WILDWOOD LAKE DAM

NDI ID NO. PA-00157

PHASE I INSPECTION REPORT

NATIONAL DAM INSPECTION PROGRAM

WILLOWOOD LAKE DAM
 Profile - Top of Dam
 Scales: 1" = 100' Hor
 1" = 2' Ver

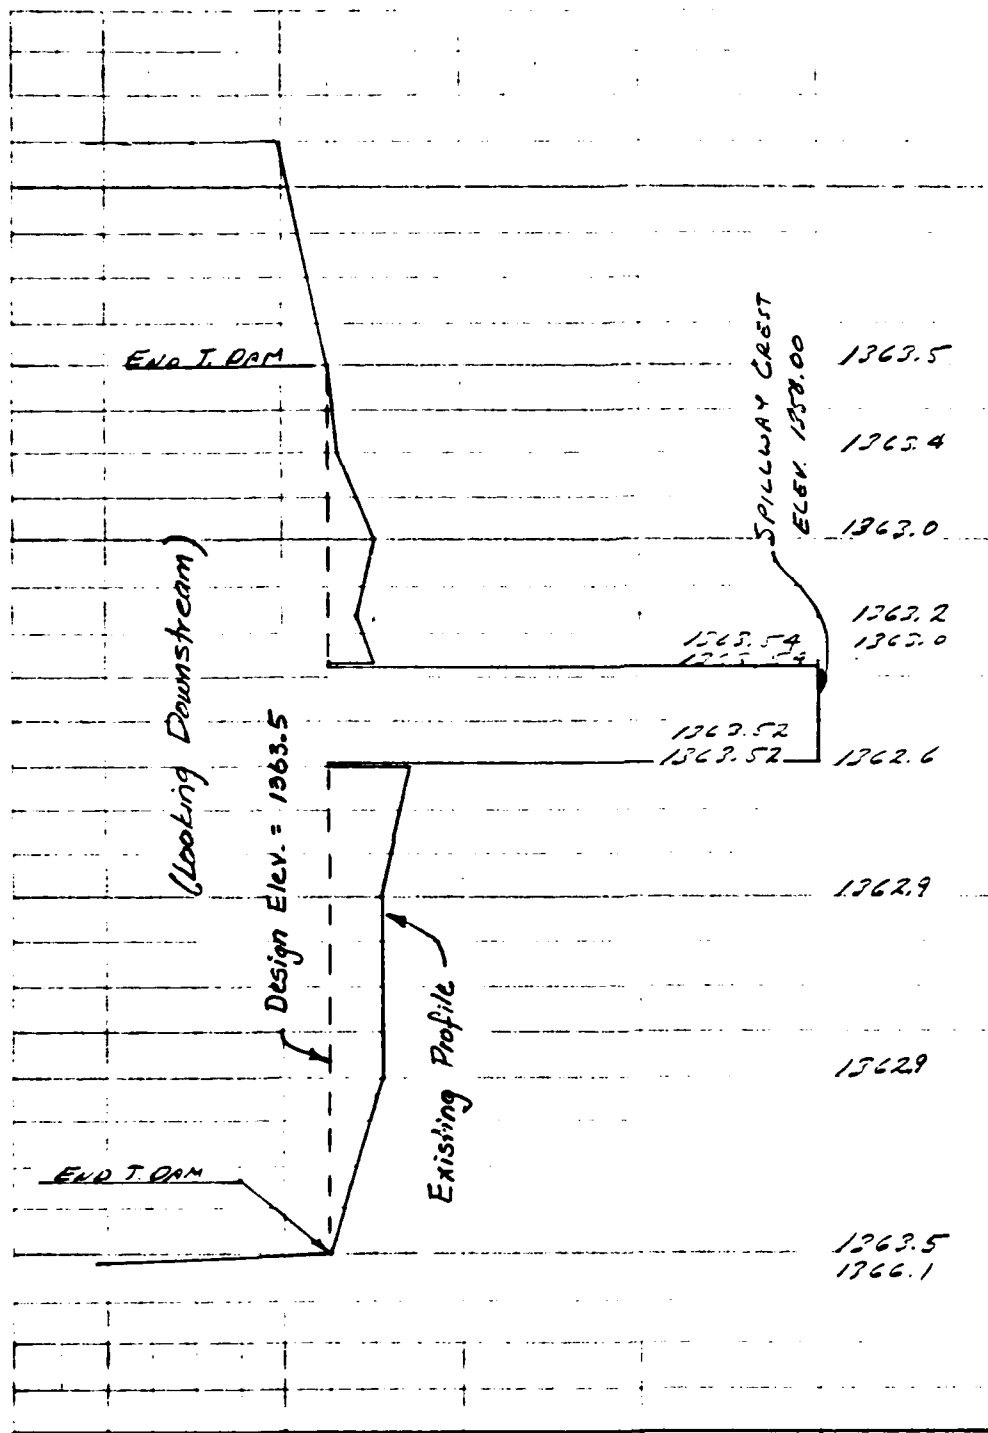
b. Embankment. The top of the dam is 8 feet wide and covered with a growth of grass (Photograph A). The survey data show that elevations along the top of the dam vary from a low point adjacent to the spillway at Elevation 1362.6 to the design elevation of 1363.5 at the abutments.

(2) Embankment. The top of the embankment is lower than its design elevation over most of its length. The lowest point is at Elevation 1362.6, which is 0.9 foot lower than the design level. Accordingly, the existing spillway capacity is less than its maximum capacity.

(1) Fill all low areas on the top of the dam to the design elevation of 1363.5.

PHASE I INSPECTION REPORT
NATIONAL DAM INSPECTION PROGRAM
WILDWOOD LAKE DAM
WILDWOOD PARK OUTING CLUB, INC.
**RESULTS OF
VISUAL INSPECTION**
MARCH 1981 EXHIBIT B-1

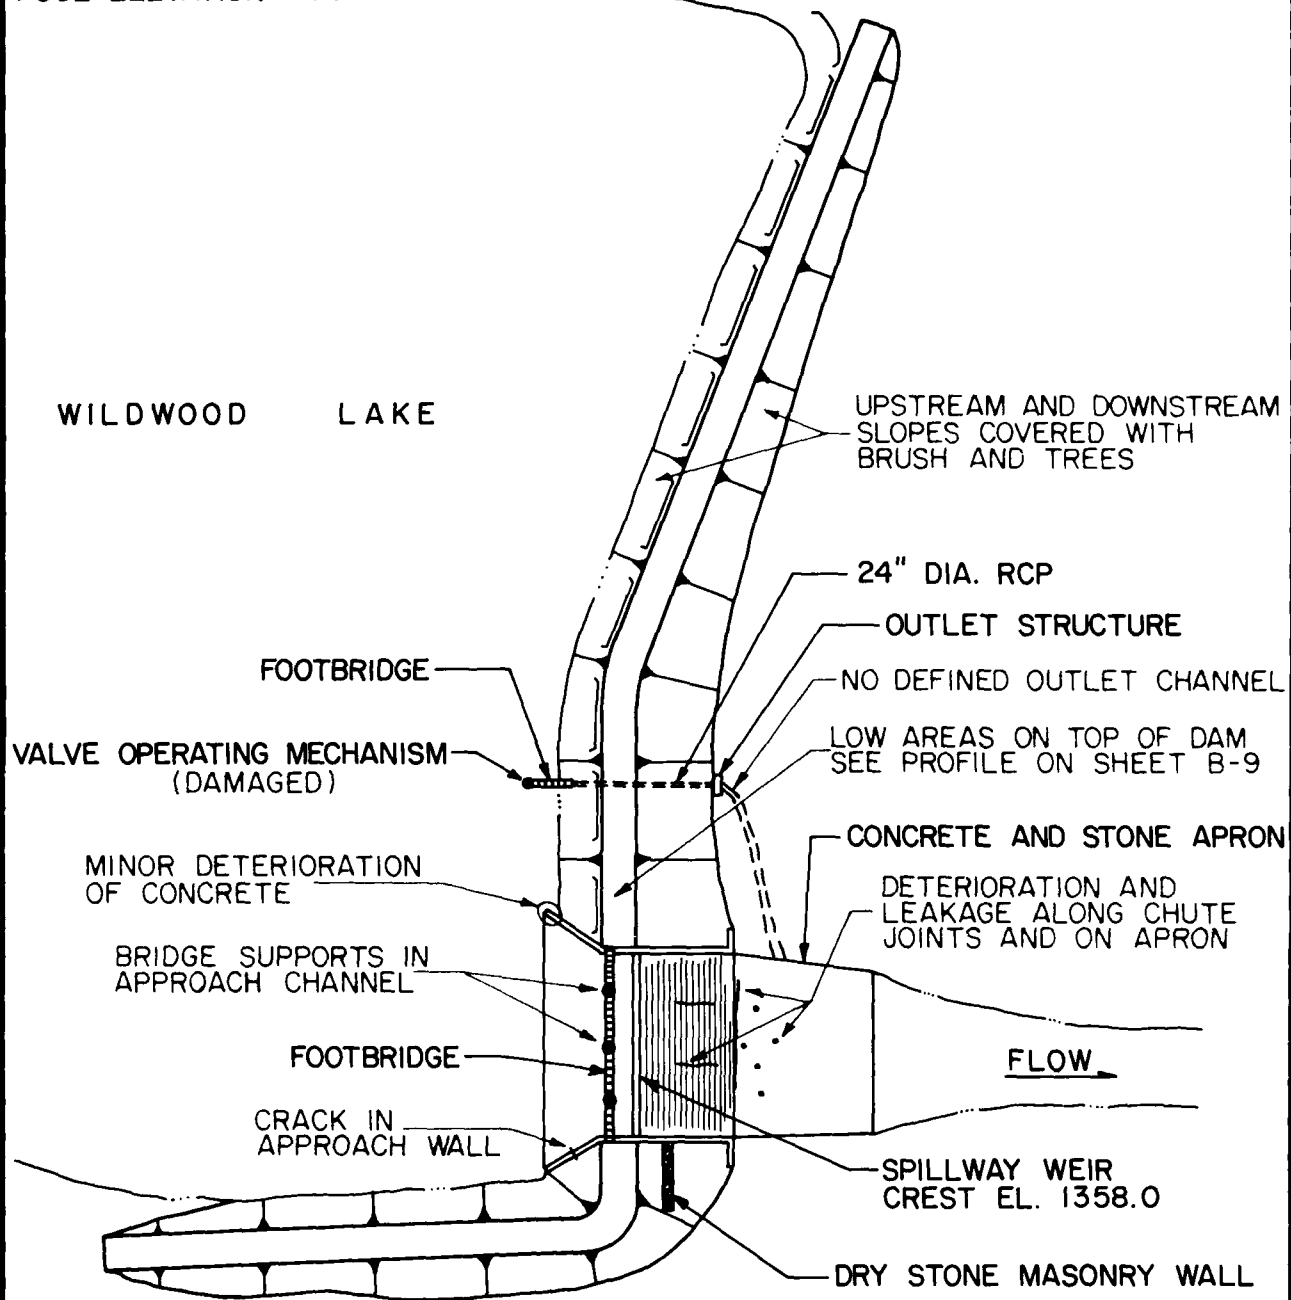
a. General. The overall appearance of the dam is fair. Some deficiencies were observed as noted below. A sketch of the dam with the locations of deficiencies is presented on Exhibit B-1 in Appendix B. Survey information acquired for this Report is summarized in Appendix B. Datum used for the survey was the spillway crest level, Elevation 1358.0. On the day of the inspection, the pool was at the spillway crest level.
